[State Clearinghouse No. 2008121080]

## **Los Angeles International Airport (LAX) Bradley West Project**

## **Responses to Comments and Corrections and Additions to the Draft EIR**

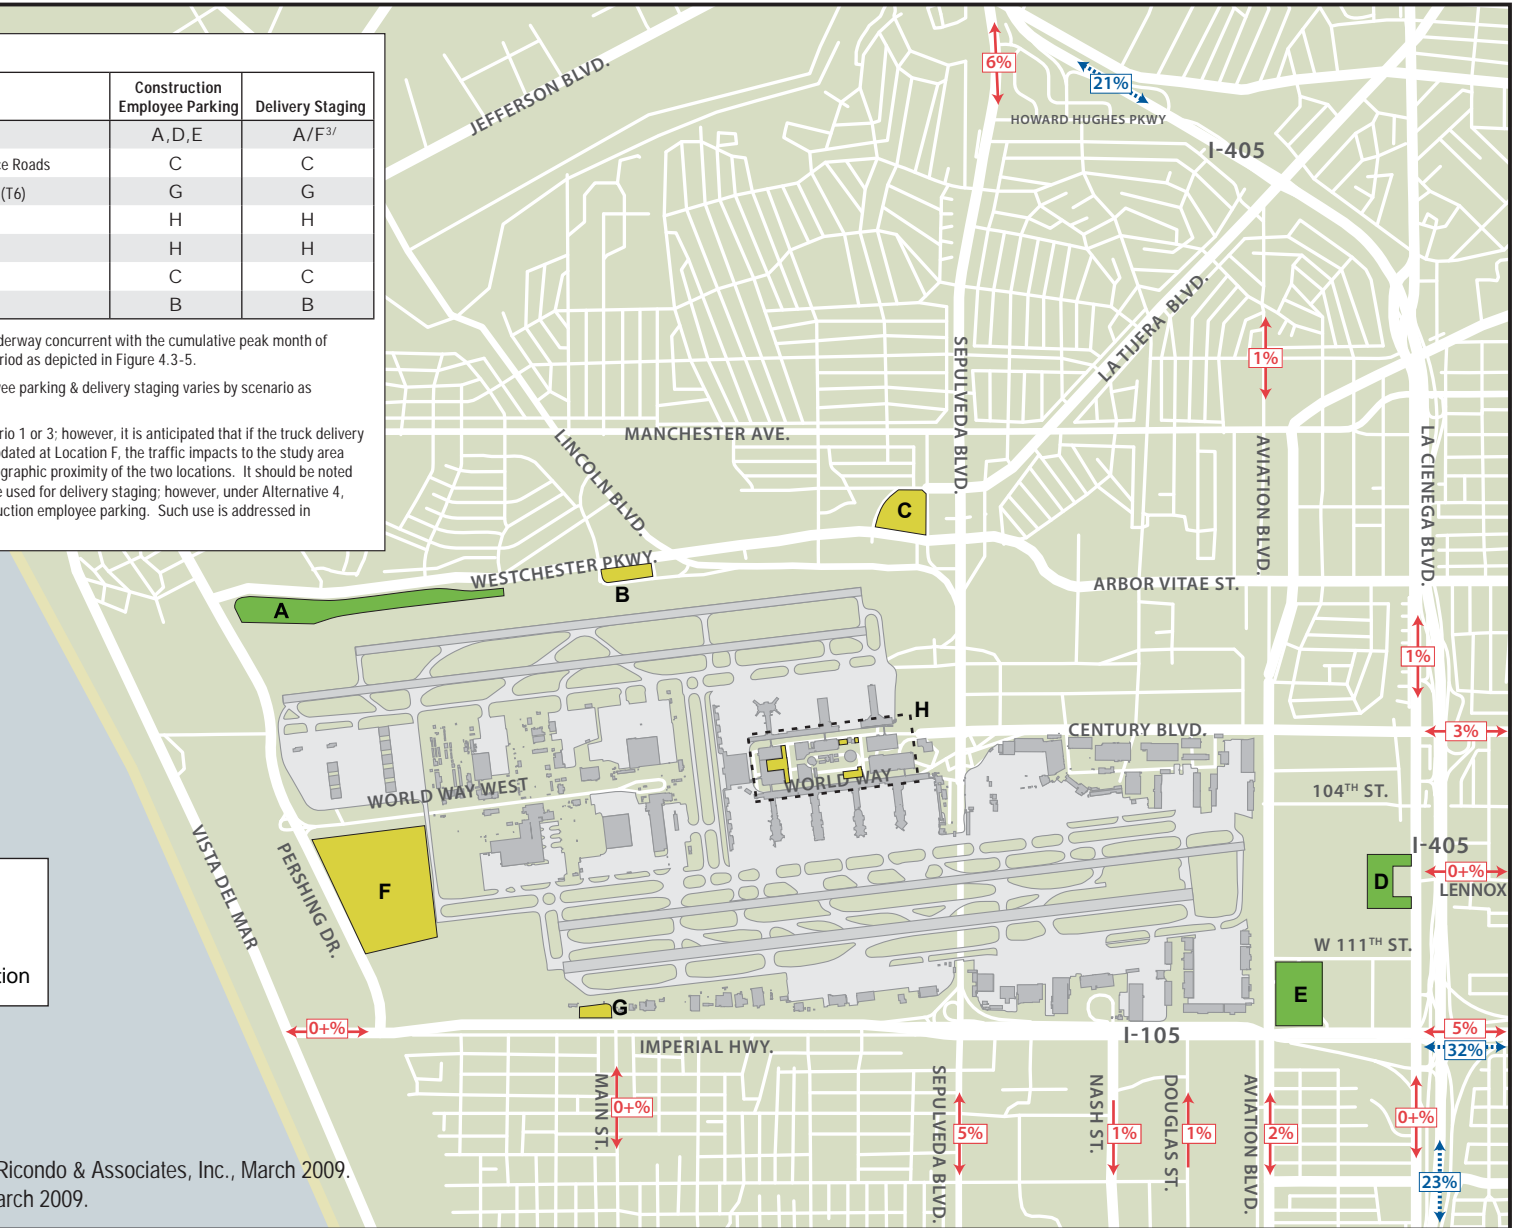
**Comment:** Please explain the discrepancy between: (1) Figure 4.3-6, which indicates that the West Construction Staging Area (referred to as location F in Figure 4.3-6) is one of the parking and staging locations for the Bradley West Project, and (2) the analysis in Chapter 4.3 of the DEIR, which only discusses the Northwest Construction Parking/Staging Area, Southeast Construction Parking/Staging Area, and East Contractor Employee Parking Area.

As described under Scenario 1 and Scenario 3 beginning on page 4-196 of the Bradley West Project Draft EIR, the analysis for these construction traffic scenarios was based on the assumption that construction employees and vehicle staging would be accommodated in the Northwest Construction Staging/Parking Area. Page 4-199 of the Bradley West Project Draft EIR also notes that under Scenario 1, LAWA may elect to use an employee parking area on the west side of the airport accessed via World Way West. This location is the West Construction Staging Area depicted as Location "F" in Figure 4.3-6 on page 4-207 of the Bradley West Project Draft EIR. As a point of clarification and correction, however, the use of the West Construction Staging Area for contractor employee parking is not included in the proposed project, but rather is an option presented as Alternative 4 in Chapter 6 of the Bradley West Project Draft EIR. Under the proposed project, the West Construction Staging Area would only be used for construction staging. For the purpose of the construction traffic analysis completed for the Bradley West Project Draft EIR, the truck delivery trip assignments for the West Construction Staging Area were assumed to be the same as for the Northwest Construction Staging/Parking Area (i.e., truck trips would occur on Imperial Highway and Pershing Drive). Therefore, for consistency with the construction traffic analysis completed for the proposed project, Figure 4.3-6 on page 4-207 of the Bradley West Project Draft EIR has been modified to remove contractor employee parking from the West Construction Staging Area, but still show the area as being used for construction staging. Also, the paragraph at the top of page 4-199 of the Bradley West Project Draft EIR has been supplemented to clarify that the use of the West Construction Staging Area for construction employee parking is reflected in Alternative 4, as addressed in Chapter 6 of the Bradley West Project Draft EIR. Please see Chapter 3, Corrections and Additions to the Bradley West Project Draft EIR.

14. Figure 4.3-6 on page 4-207 of the Draft EIR has been revised to clarify that the West Construction Staging Area would only be used for construction staging under the proposed project. Please see the following revised figure.
